ADDENDUM NO. 1
March 18, 2024

MEADOWLANDS WET WELL REPLACEMENT AND BYPASS

LIFT STATION SITE PLAN

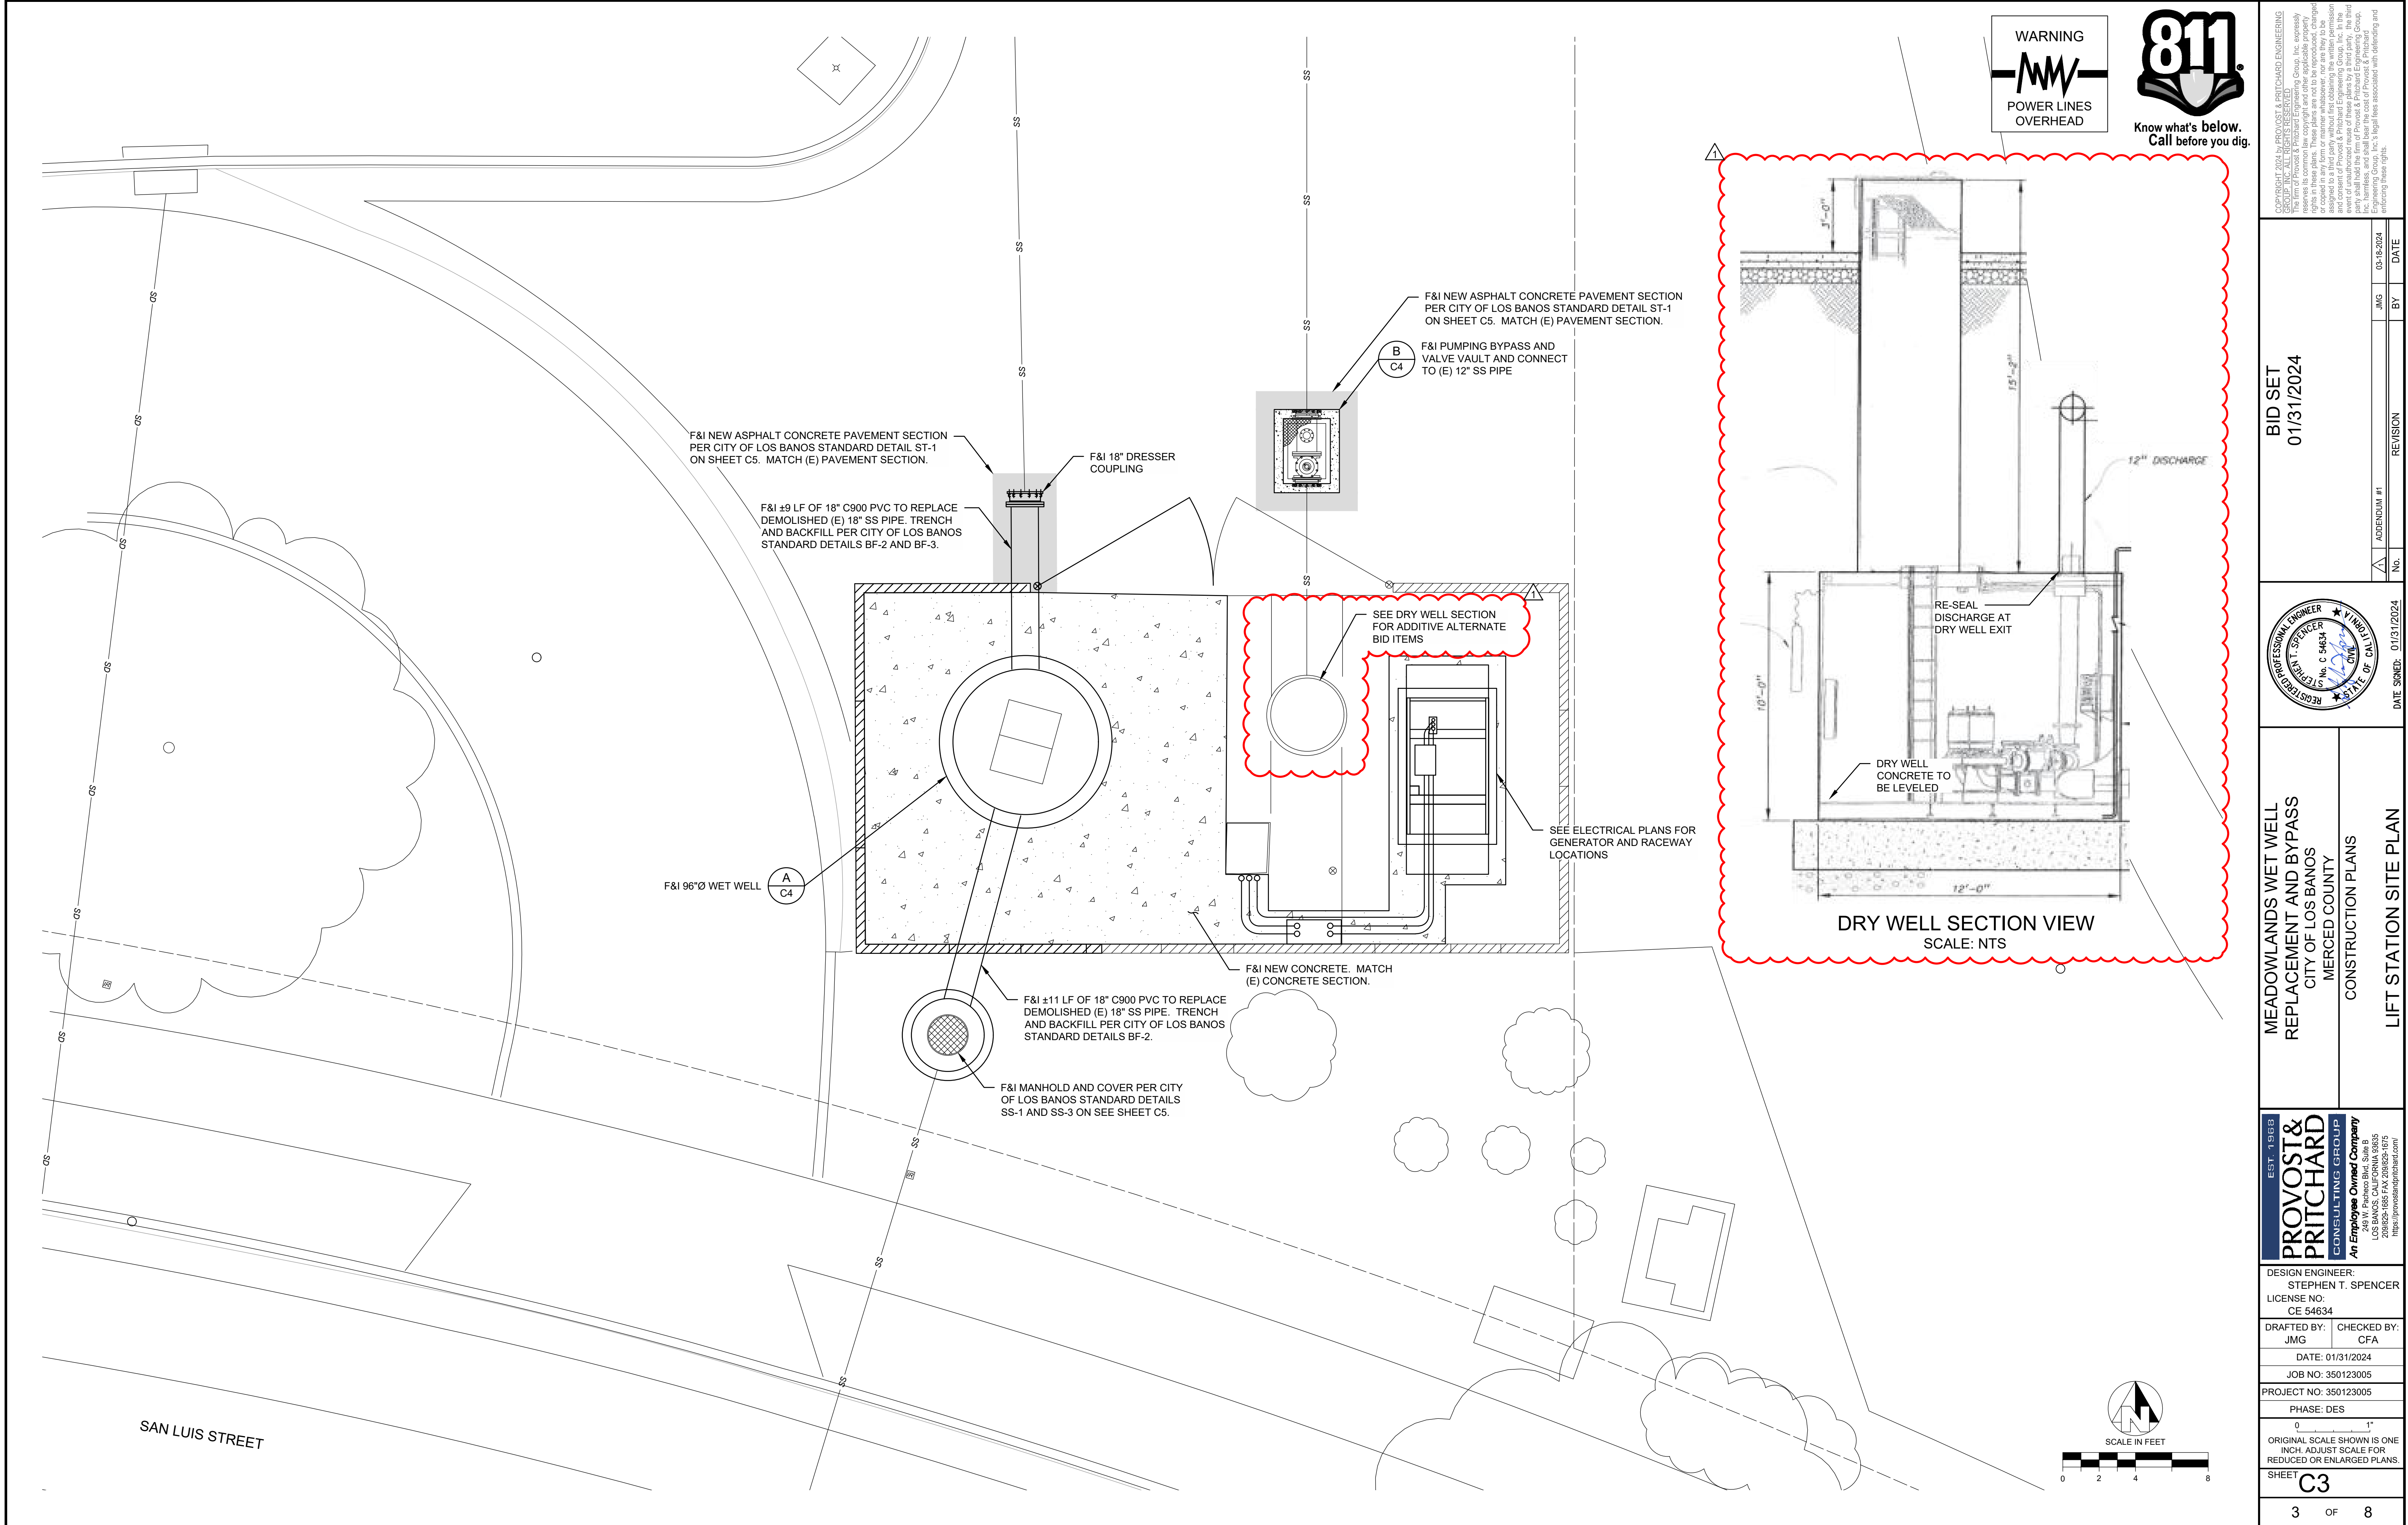
SHEET C3 OF PLANSET

Drawing C3 shows a section view of the dry well and indicates the concrete base of the dry well to be leveled along with the location of where the discharge pipe is to be re-sealed.

Bid Item A2 – Dry Well Concrete Leveling and Re-seal: Payment under this item shall be considered full compensation for all labor, materials, tools, equipment and incidentals required to level the concrete at the base of the dry well and re-sealing the discharge pipe at the location where it exits the dry well.

1 SINGLE LINE DIAGRAM
SCALE: NTS

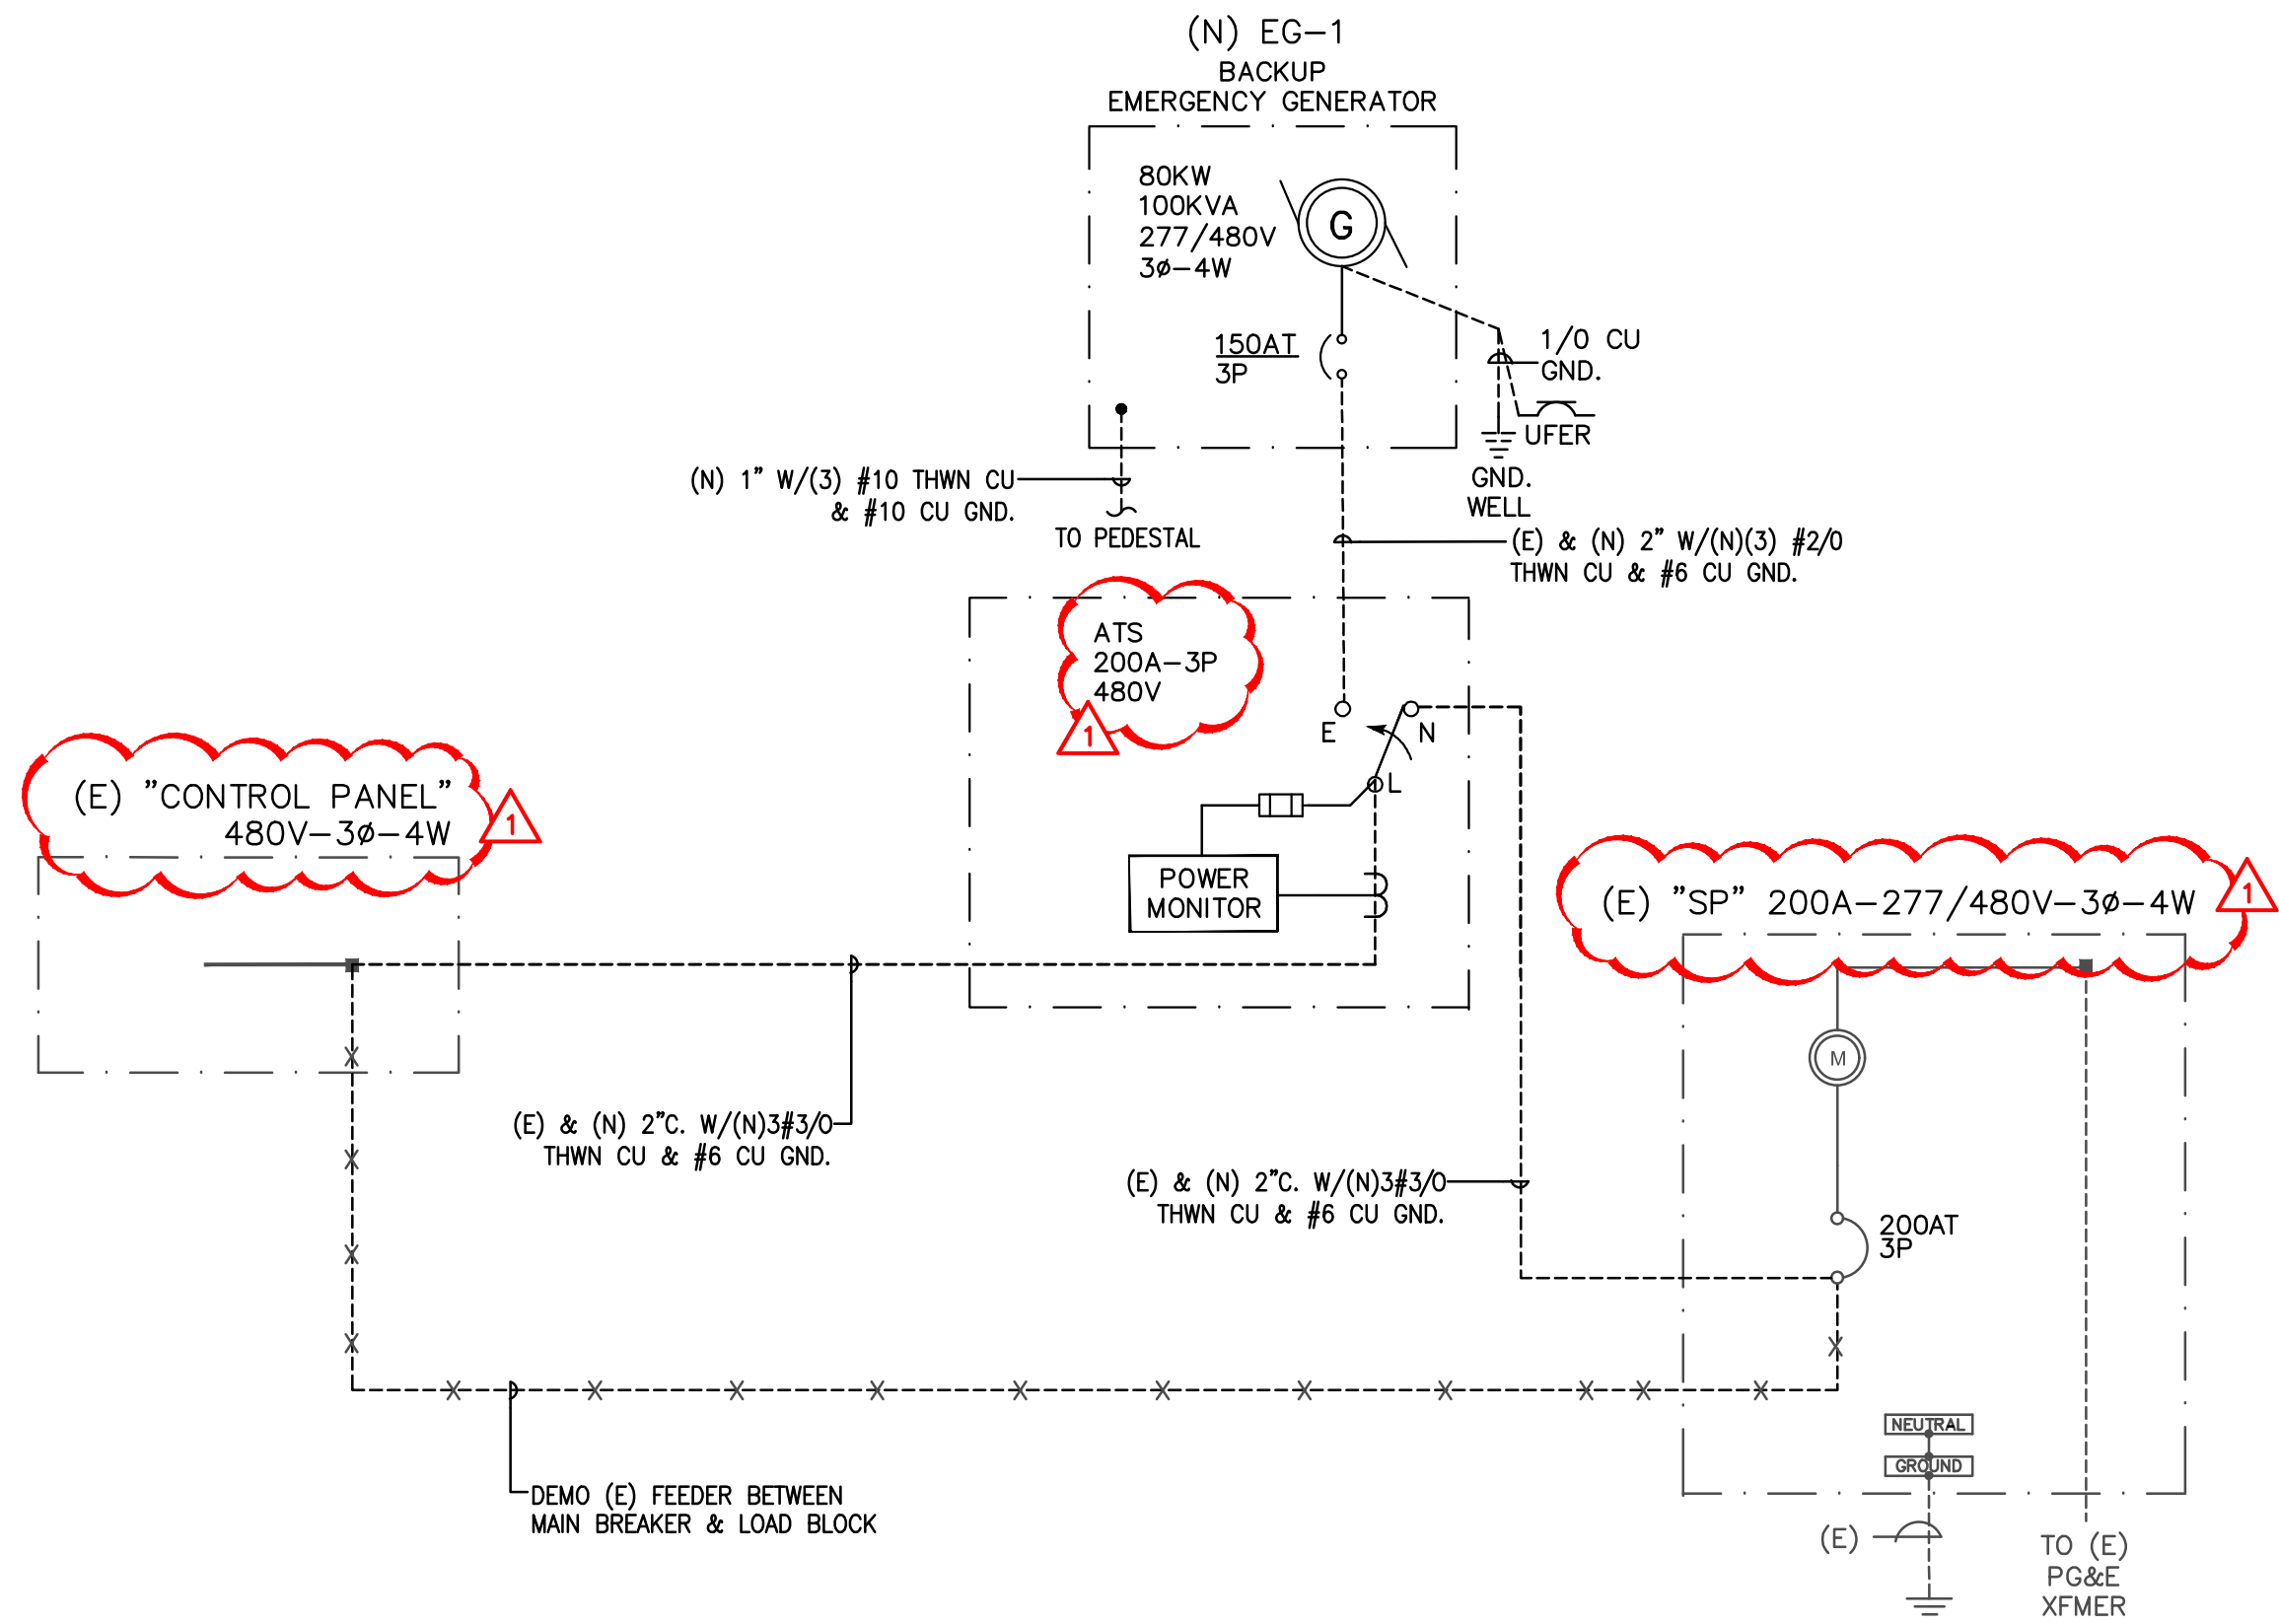
SHEET E2.1 OF PLANSET

Drawing E2.1 has updates to amperage and voltage shown in the single line diagram.
